**RE: REMEDIAL INVESTIGATION/FOCUSED FEASIBILITY STUDY ADDENDUM
COMFORT SUITES PROPERTY
7200 FUN CENTER WAY
TUKWILA, WASHINGTON
FARALLON PN: 2812-001**

Farallon Consulting, L.L.C. (Farallon) has prepared this letter as an addendum to the *Remedial Investigation/Focused Feasibility Study* dated October 18, 2022 prepared by Farallon on behalf of Eastwind Investments, Inc. (Eastwind) (RI/FFS) for the Comfort Suites Property at 7200 Fun Center Way in Tukwila, Washington (herein referred to as the Comfort Suites Property) (Figure 1). The Comfort Suites Property is enrolled in the Washington State Department of Ecology (Ecology) Voluntary Cleanup Program (VCP) Expedited Process and assigned Facility Site Identification (ID) No. 18434384 and VCP Project ID No. XN0027. The Comfort Suites Property is part of the cleanup site known to Ecology as the Family Fun Center Site (Cleanup Site Identification No. 385) (Figure 2). The Family Fun Center Site historically was enrolled in the VCP by the former owner, Family Fun Center Tukwila LLC. The RI/FFS was prepared with the intention of pursuing a property-specific No Further Action (NFA) determination for only the Comfort Suites Property. Ecology

FIGURE 2A

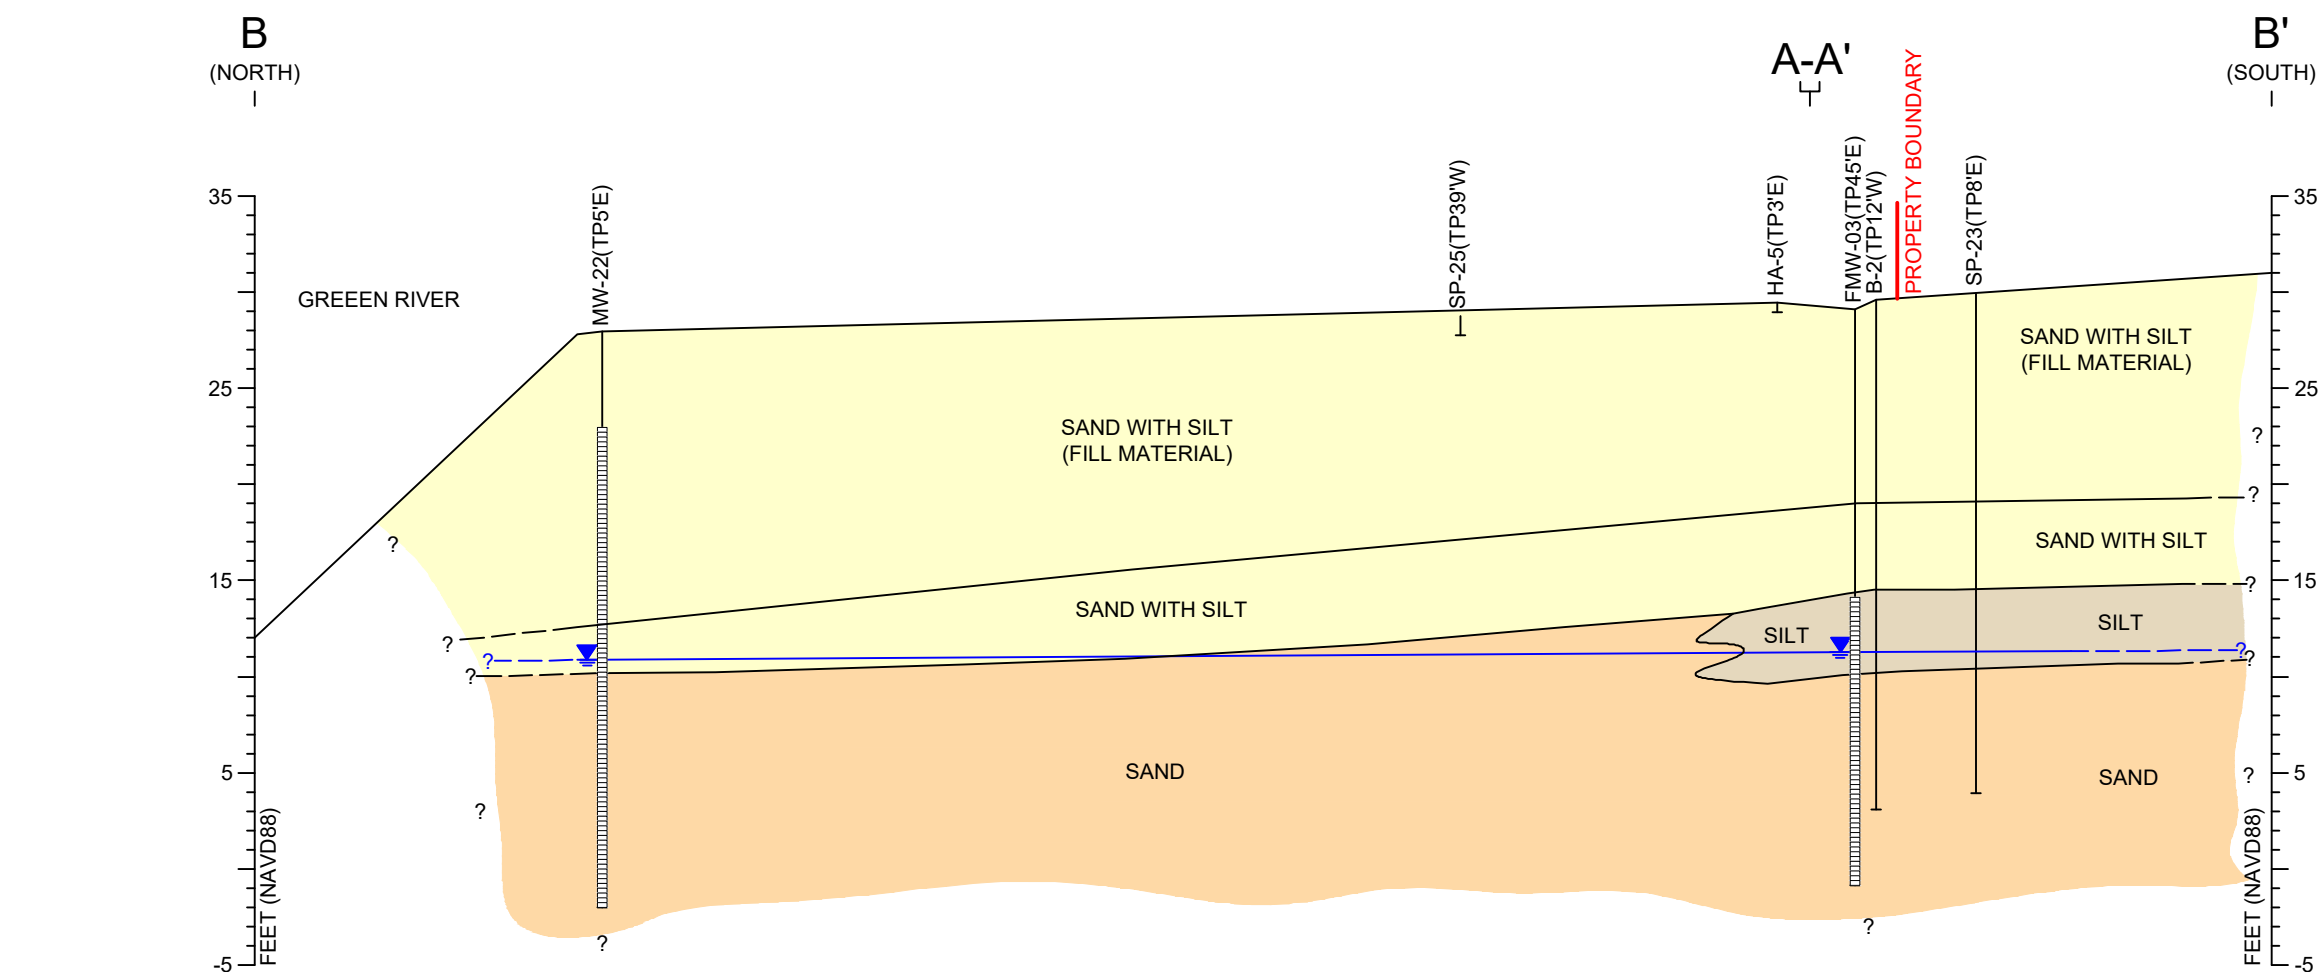
- Revised versions of RI/FFS Figures 2A and 2B showing geological cross sections of the Comfort Suites Property updated to include the depth and thickness of fill material;
- A revised version of RI/FFS Figure 3 showing the approximate locations of borings and monitoring wells constructed as part of investigations performed at the Comfort Suites Property and Family Fun Center Site;

Farallon has revised these figures and tables as requested by Ecology. For convenience, a complete set of the RI/FFS figures and tables that includes these updates is attached.

FIGURE 4A

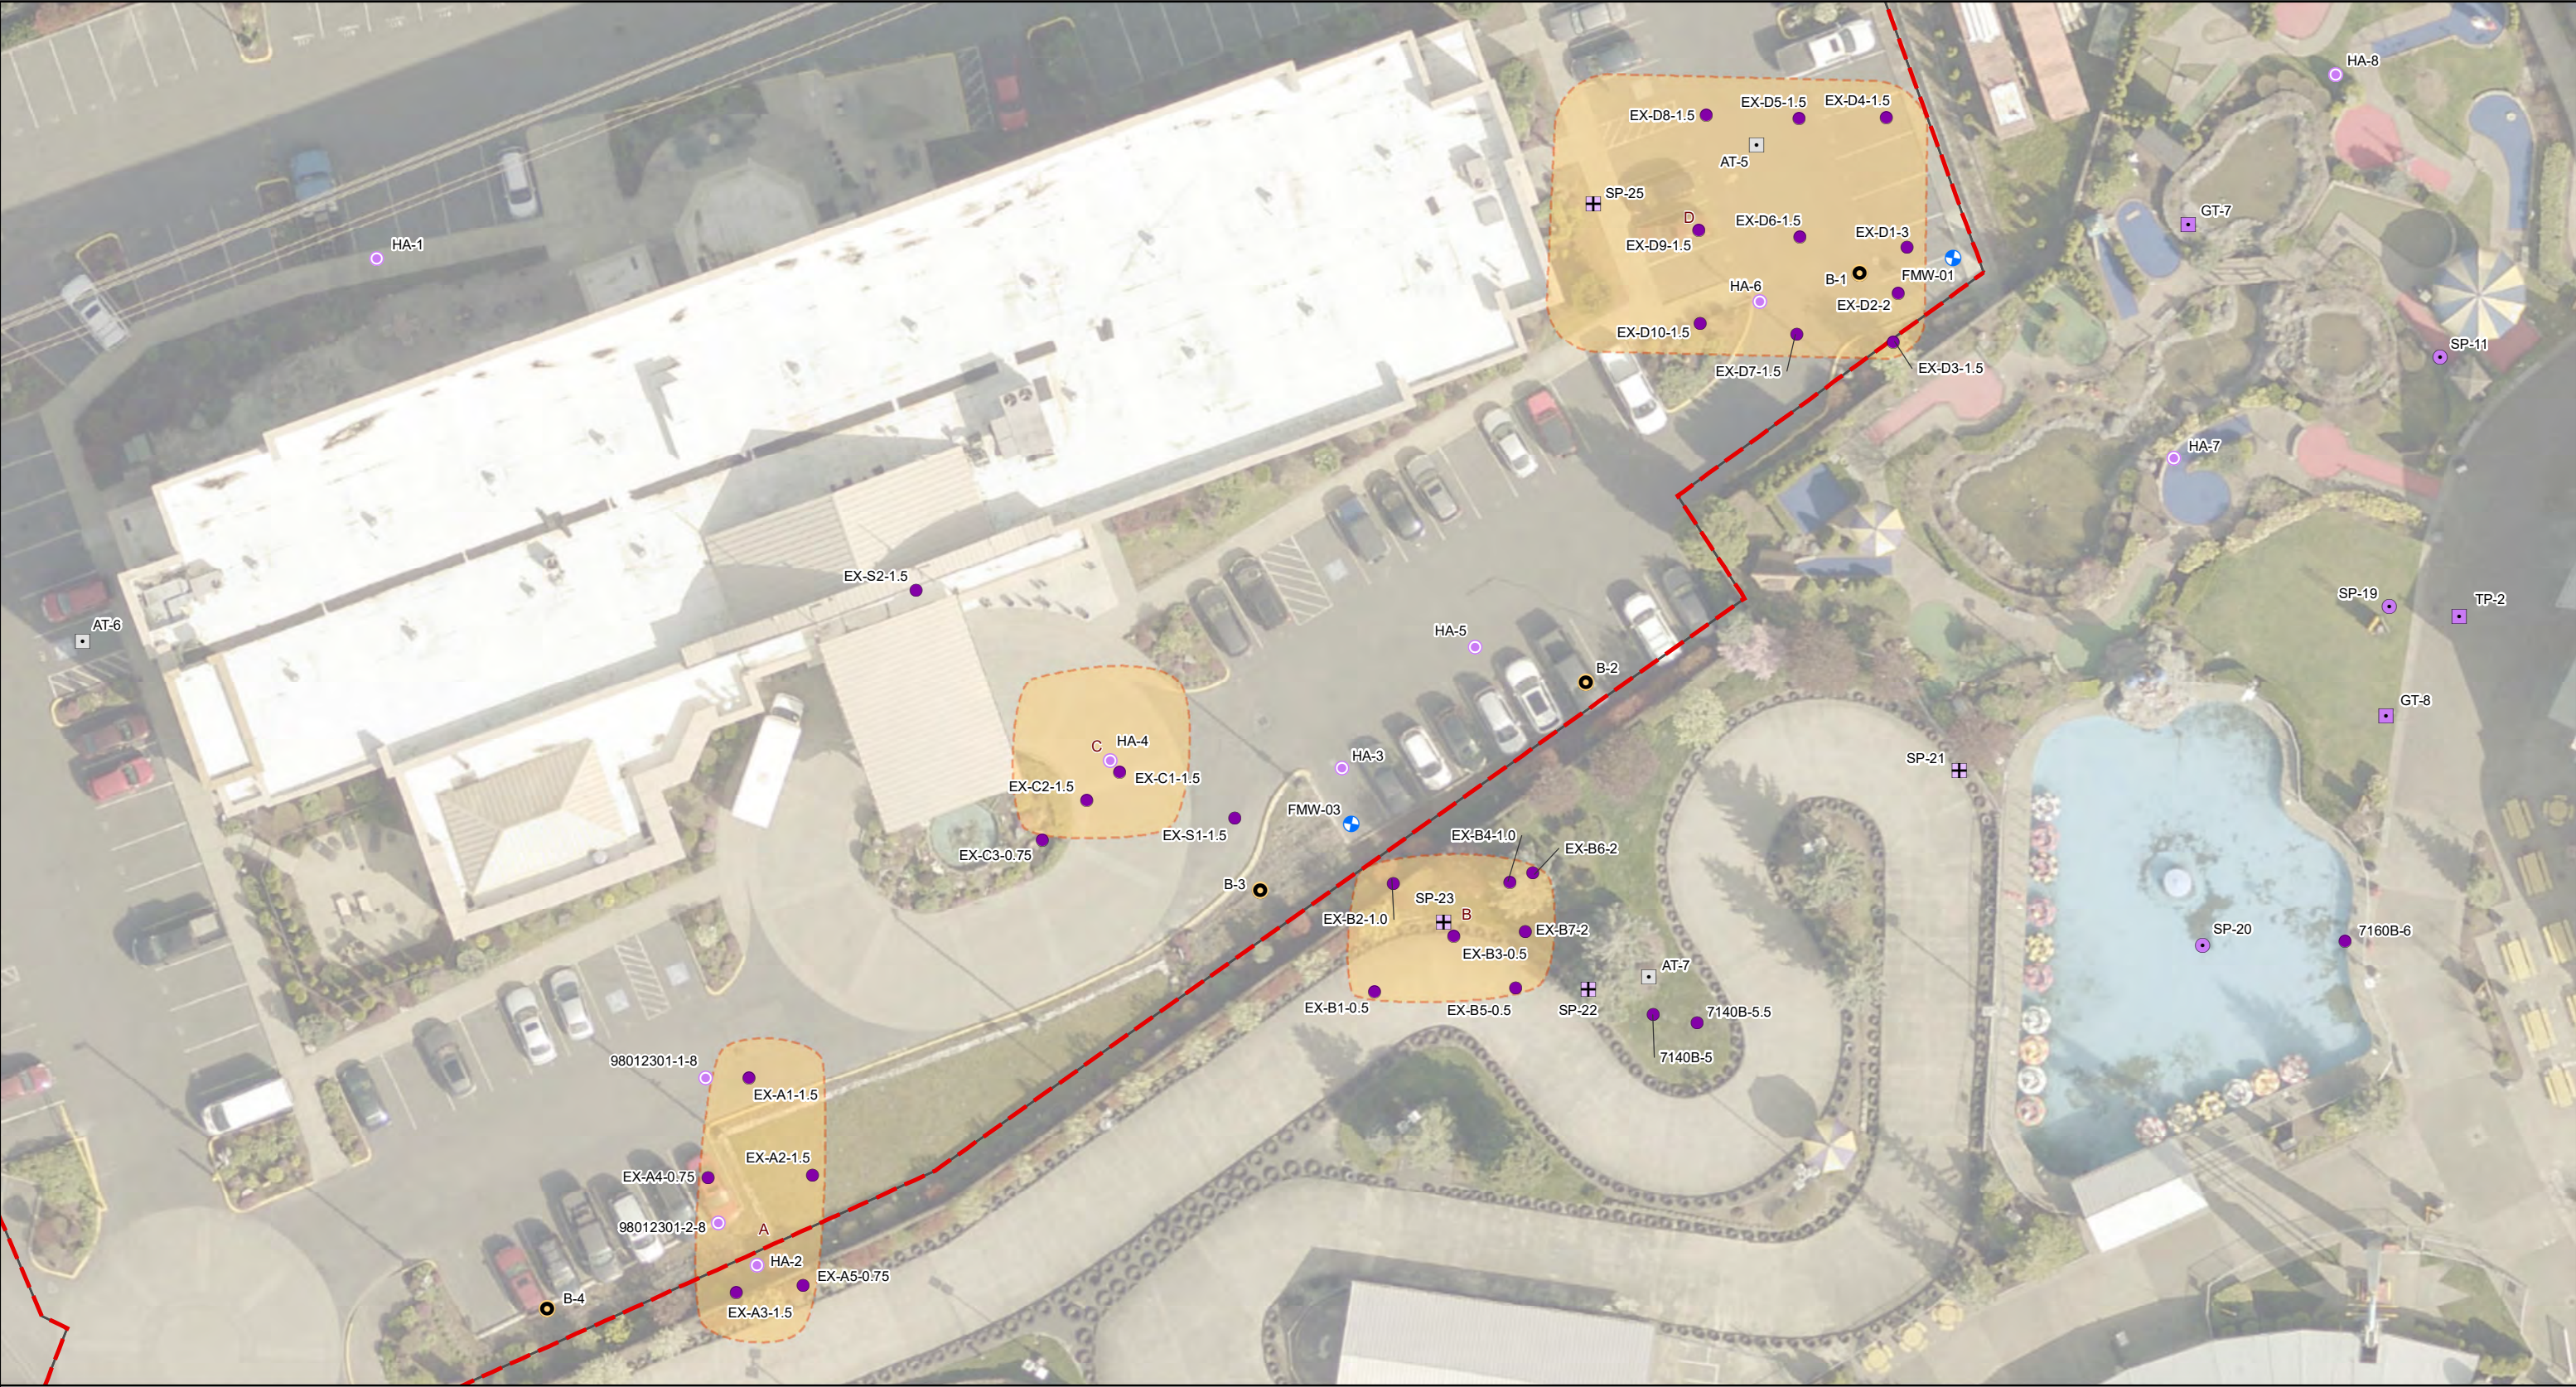
- A revised version of RI/FFS Figure 4 showing the approximate location of the containment and capping area of the Fun Center Site presented on Figure 8 from the *Revised Cleanup Action Report, Family Fun Center Site, Tukwila, Washington* dated February 19, 2002, prepared by GeoEngineers; and
- A revised version of Tables 2 through 6 updated to indicate the parcels on which soil samples were collected and sampling locations where soil was subsequently excavated.
